Subject: Draft meeting notes with attachments for PEF/LNP Meeting on 01/19/2012
(UNCLASSIFIED)
Sent Date: 1/25/2012 12:55:26 PM
Received Date: 1/25/2012 12:56:06 PM
From: Hambrick, Gordon A SAJ

SUBJECT: Progress Energy Florida/Levy Nuclear Plant project – SAJ-2008-00490
Meeting/Teleconference – PEF, NRC, EPA & Corps

Levy Nuclear Plant Monitoring Plan Recommendations

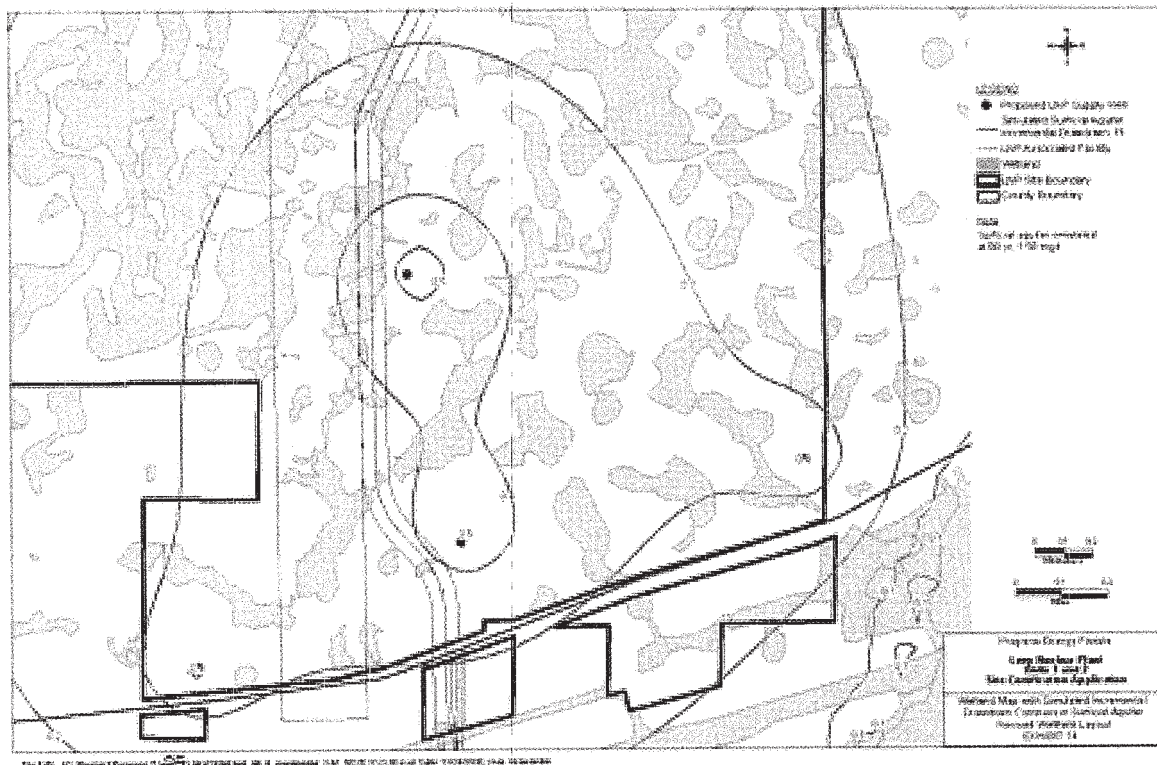
PEF proposes to have four water supply wells constructed (Figure 1) that will withdraw on average 1.5 million gallons per day (mgd) and up to 5.8 mgd during peak periods of energy use. Excessive groundwater withdrawals are known to have detrimental impacts on hydrology and the ecology of the overlying wetlands (Hoffstetter, 1990; Sonenshein, 1990). While the landscape in the project area of influence is not pristine and has been impacted by silviculture and the Cross Florida Barge Canal, areas within the project footprint have been categorized as wetlands and thus must be conserved in both form and function [Clean Water Act, Section 404(b)]. Modeling scenarios were completed by PEF at the direction of the Southwest Florida Water Management District (SWFWMD) to analyze potential hydrological changes to the aquifer underlying the site. The scenarios estimated that drawdowns would only depress the groundwater levels by 0.4 ft in a small area immediately surrounding the wellfield (Figure 1). This model scenario was considered by us as an approximation of the spatial extent and the severity of any potential impacts to the overlying wetlands in both form and function.

Our review of the modeling assumptions for this particular modeling scenario indicates that it does not provide sufficient information (low confidence) to make any definitive decisions on the type and extent of impact the proposed groundwater withdrawals would have on the overlying wetlands. The model results provide a very coarse temporal resolution of the drawdown effects because they are averaged over 60 years. This coarse resolution does not account for changes in inter-annual/decadal precipitation and annual groundwater hydrologic patterns that reflect normal fluctuations experienced by the natural system. The periodicity and magnitude (duration and depth) of the drawdown are strong drivers shaping wetland structure (Kirkman, et al., 2000). If groundwater usage is averaged during annual hydrological periods, then the seasonal effects of groundwater drawdowns can be missed. For example, the modeled scenario does not take into account the peak water usage of up to 5.8mgd in relation to the natural hydrologic cycle that could include an unusually dry precipitation year coupled with a higher than average temperature year. As peak energy use occurs during the summer, there is an increased draw on the groundwater in excess of the 1.58mgd average and approaching the 5.8mgd maximum. Due to the lack of a normal amount of rainfall to recharge the aquifer, the groundwater levels remain at levels below the average. As the winter months ensue, the energy use once again peaks and groundwater withdrawals increase greater than the average on an already depressed aquifer causing the groundwater levels to fall even lower. The current modeled scenario does not allow us to determine the extremes that can occur in the system. It is these extremes, although they may be few and far between, that must be taken into consideration, as they can be the “tipping points” that result in greater impacts (area and degree) to the natural ecosystem from which they can’t recover.
